UNITED STATES PATENT AND TRADEMARK OFFICE

Office Action Summary

10/534,837

DETAILED ACTION

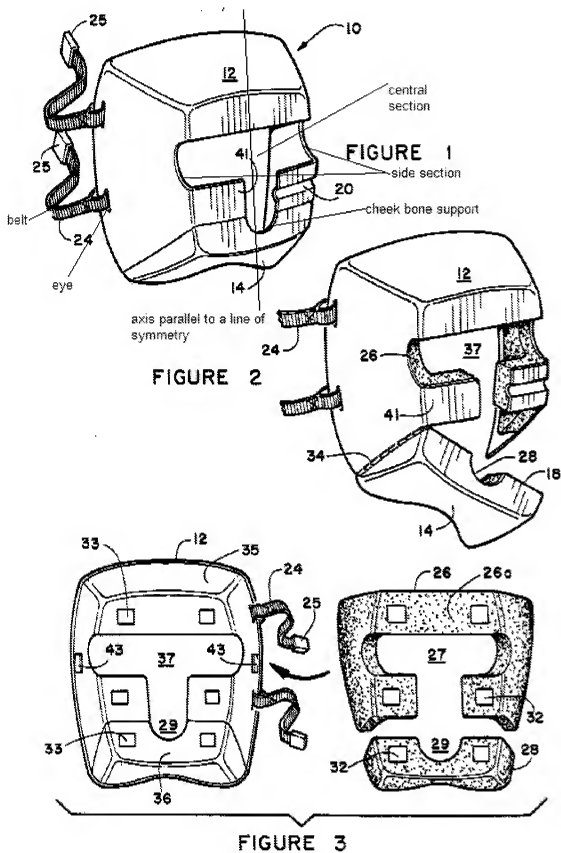
Mazzei disclose a headrest for a patient-bearing surface with rigid-support shell (12, column 5 lines 8-12) and a cushion (26,28) releasably connectable (column 6 lines 36-59) with the rest shell, characterized that the rest shell has an approximately horseshoe-shaped (see fig 1) form with

a central section (37) for supporting the rear or forehead of a head, which central section (37) has a support surface of approximately spherical shell shape, and with two side sections conform at least approximately to a common cylindrical surface whose axis runs parallel to a line of symmetry of the head support running between the side sections with there being a cheekbone (14) on each of the side sections which cheekbone support projects in the direction toward the other side section (see figure below).

14. Further, applicant argues that the helmet of Mazzei '333 does not disclose a support surface of an approximately spherical shell shape with two cylindrical side sections. A broad interpretation of "approximately spherical shell shaped" has been interpreted to be met by the Mazzei reference since the disclosed helmet can be comprised of two portions that are an approximately spherical shell shaped central sections (see illustrated figure represented below).
